Technical Service Bulletin

SUBJECT:			No:	TSB-19-42A-004
WINDOW GLASS RUNCHANNEL & DOOR OPENING WEATHERSTRIP REMOVAL & INSTALLATION DATE: April 2019				
- SERVICE MANUAL REVISION			MODE	2016-19 Outlander
CIRCULATE TO:	[] GENERAL MANAGER	[X] PARTS MANAGER [X] TECHNICIAN		
[X] SERVICE ADVISOR	[X] SERVICE MANAGER	[X] WARRANTY PROCESSOR [] SALES MANAGER

This TSB updates the Body section of the affected Service Manual, to correct the window glass runchannel and door opening weatherstrip removal and installation procedure.

ADHESIVE

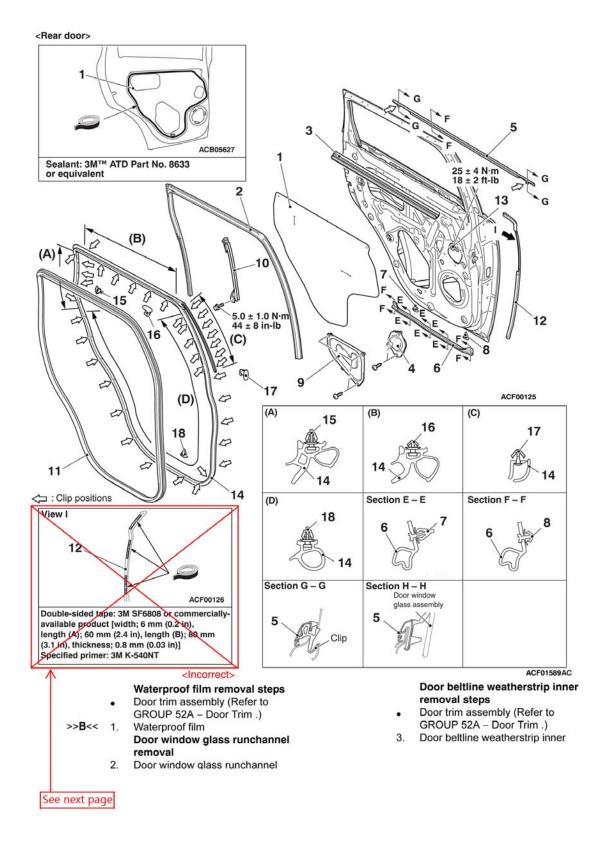
Please make the indicated changes to the 2016 - 2019 Outlander Service Manual, Group 42-Body -> Door -> Specifications -> Adhesive.

Item		Specification		
Door waterproof film		3M ATD Part No.8633 or equivalent		
Door opening front weatherstrip Incorrects		Double-sided tape: 3M SF6808 or commercially-available product [width; 6 mm (0.2 in), length (A); 60 mm (2.4 in), length (B); 80 mm (3.1 in), thickness; 0.8 mm (0.03 in)]		
		Specified primer: 3M K-540NT		
	<correct></correct>	Double-sided adhesive tape: 3M SF6812 or equivalent (J) thickness; 1.2 mm (0.05 in), width; 6 mm (0.2 in), length; 60 mm (2.4 in) (K) thickness; 1.2 mm (0.05 in), width; 6 mm (0.2 in), length; 60 mm (0.1 in)		
		length; 80 mm (3.1 in) (L) thickness; 1.2 mm (0.05 in), width; 4 mm (0.2 in),

<Correct>

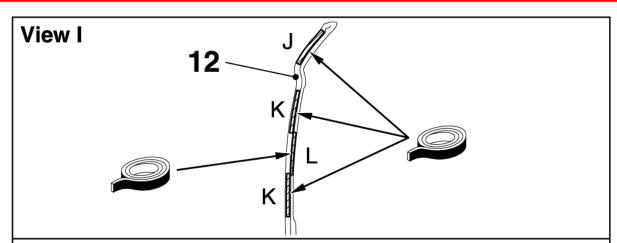
Please make the indicated changes to the 2016 - 2019 Outlander Service Manual, Group 42-Body -> Door -> Window Glass Runchannel & Door Opening Weatherstrip -> Removal and Installation.

Double-sided tape: 3M SF6812 or equivalent

(J) thickness; 1.2 mm (0.05), width; 6 mm (0.2 in), length; 60 mm (2.4 in)

(K) thickness; 1.2 mm (0.05), width; 6 mm (0.2 in), length; 80 mm (3.1 in)

(L) thickness; 1.2 mm (0.05), width; 4 mm (0.2 in), length; 80 mm (3.1 in)

Specified primer: 3M K-540NT
